CPUC Meeting Materials

Weekly Non-Destructive Examination Program Updates

December 20, 2013

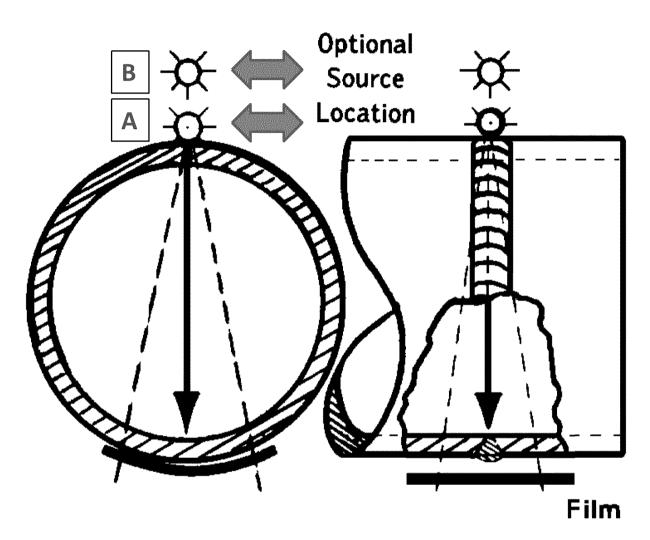
- SED: API 1104 states that 4 exposures must be taken if source is >13mm from weld. The PG&E reader sheets state over 13mm in all cases, but only 3 exposures were used.
 - PG&E believes that SED is misinterpreting what the WIX reader sheets are specifying. PG&E acknowledges that the absence of units adds to this ambiguity, but provides a detailed explanation on the following page.

When the radiographic source is outside but not more than 1/2 in. (13 mm) from the weld surface, at least three exposures separated by 120° shall be made for the radiographic inspection of a complete weld (DWE/SWV). In the drawing above, "A" illustrates when the radiographic source is outside (surface of pipe diameter) and no more than $\frac{1}{2}$ in. (13mm) from the weld surface.

When the radiographic source is outside and more than 1/2 in. (13 mm) from the weld surface, at least four exposures separated by 90° shall be made for the radiographic inspection of a complete weld (DWE/SWV). In the drawing above, "B" illustrates when the radiographic source is outside (surface of pipe diameter) and more than $\frac{1}{2}$ in. (13mm) from the weld surface.

On the Western Industrial X-Ray (WIX) reader sheet WIX documents the *SFD* (source to film distance) which is a line drawn directly through the center of the pipe from the outside surface of the radiation source to outside surface of the pipe where the film is in contact. Additionally, the reader sheet documents the *Source To Obj.* (source to object distance) which is a line drawn directly through the center of the pipe from the outside surface of the radiation source to inside surface of the pipe from the drawing where the arrow is pointing).

None of the information in the example above has anything to do with the $\frac{1}{2}$ in. (13 mm) requirement specified in Section 11.1.3.1 within API 1104.
